# Staff Summary Report

**SUBJECT:** Hold a public meeting for a Development Overlay for FOUNTAINHEAD OFFICE PLAZA, located at 1625 W Fountainhead Parkway.

**DOCUMENT NAME:** DRCr\_FountainheadOfficePlaza\_120908

**DPR08237** – Development Plan Review including site plan, building elevations and landscape plan.

ELEVATIONS  
10 STORY

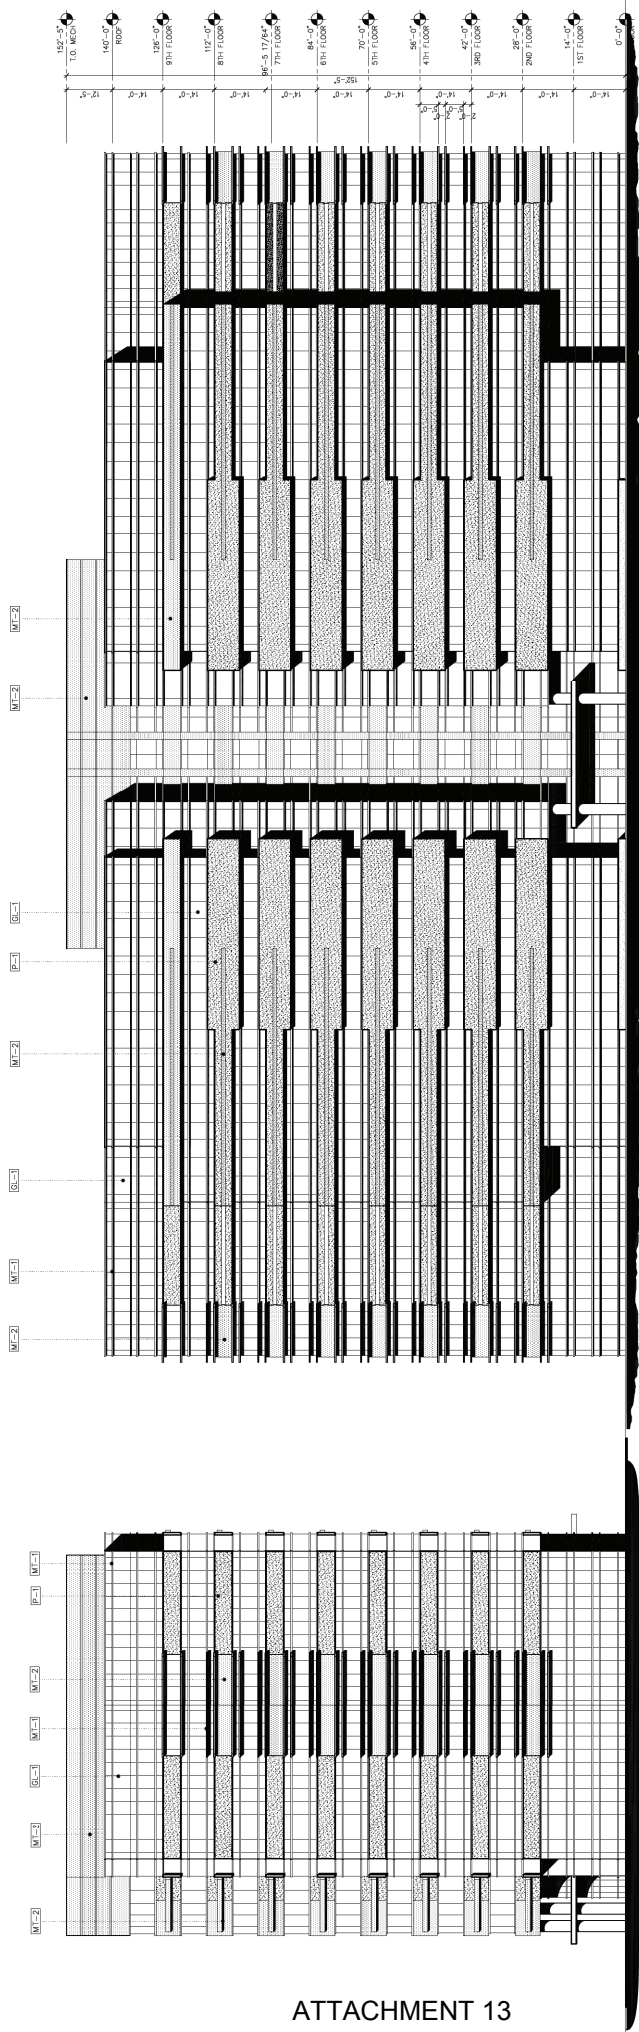
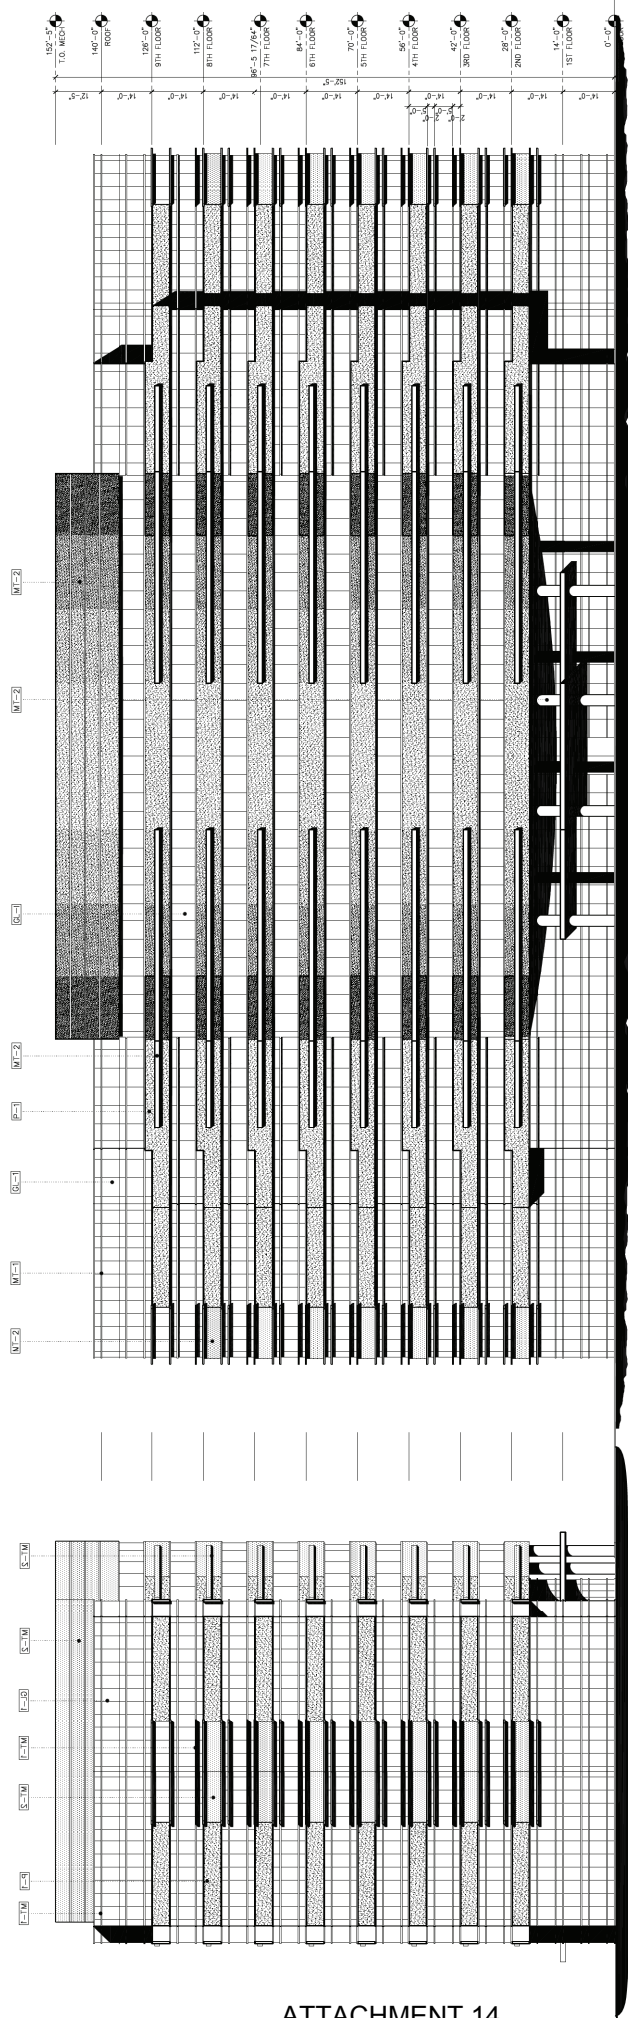
13. The materials and colors are approved as presented:  
Integral Colored Concrete – to match Dunn Edwards paint color DE6242 Wells Grey LRV 43  
Metal panel painted to match ATAS 70 Clear  
Clear anodized aluminum frame – to match Arcadia #11/Clear AC-2  
1" Insulated glass to match Versalux Blue 2000T Subdued Silver Reflectance  
Provide main colors and materials with a light reflectance value of 75 percent or less. Specific colors and materials exhibited on the materials sample board are approved by planning staff. Submit any additions or modifications for review during building plan check process.

14. Provide secure roof access from the interior of the building. Do not expose roof access to public view.
15. Conceal roof drainage system within the interior of the building.

16. Incorporate lighting, address signs, and incidental equipment attachments (alarm klaxons, security cameras, etc.) where exposed into the design of the building elevations. Exposed conduit, piping, or related materials is not permitted.
